Team member
Igor SikonczykPhone
+32 (0)466 90 04 01Email
igor.sikonczyk@eurovent.euDate
2021-04-30

Eurovent comments to draft working documents on Ecodesign requirements for VU and Energy Labelling of RVUs

1.3.2 Errors in formulas for SFP_{int_limit}

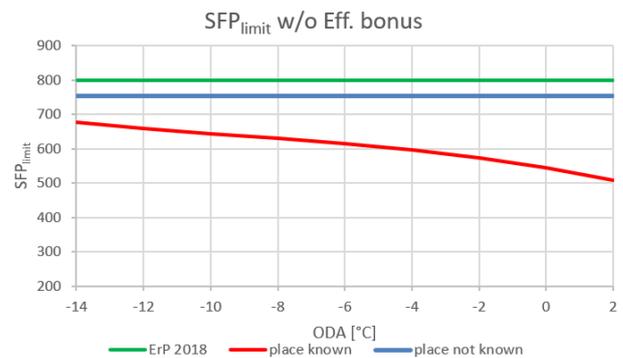
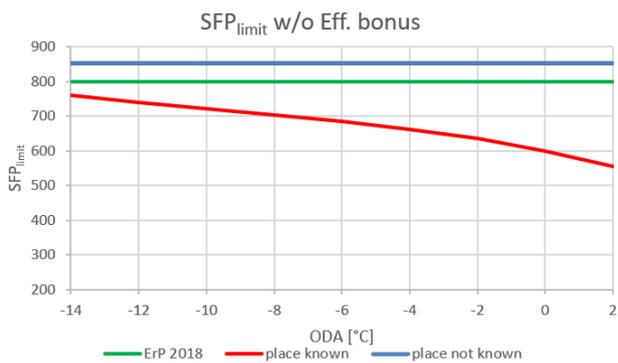
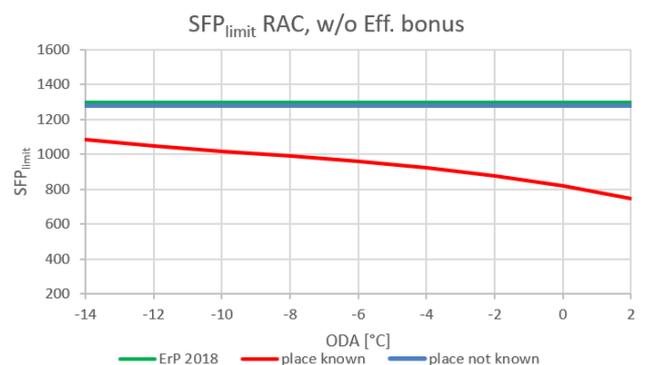
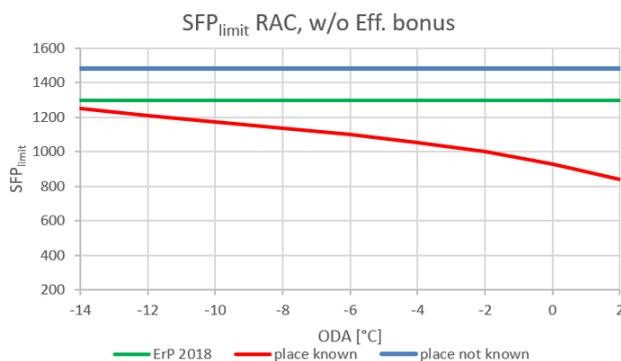
If the postulate outlined in point 1.3.1 cannot be met, we would like to point out that the proposed equations for calculating the SFP_{int_limit} may contain errors. It appears that while using various C factors, requirements for known and unknown place of installation at the lowest outdoor temperature are different. In addition, formulas for a known and unknown location are not consistent. The following graphs illustrate the problem.

C=1,15 x 1,1 (270W/m³/s for filters)

C=1,05 x 1,0 (270W/m³/s for filters)

For Other ERS

For RAC

- Equations need to be corrected so that SFP_{int_limit} value is the same for known and unknown place of installation at the lowest outdoor temperature.
- The equations need to be improved to ensure that for the best case of smart controls (highest C value), **the SFP_{int_limit} value is no higher than the current ErP 2018 limit.** (to avoid potential circumvention of ecodesign requirements explained in point 1.3.1)

- The equations should allow for consideration of multi-stage filtration.
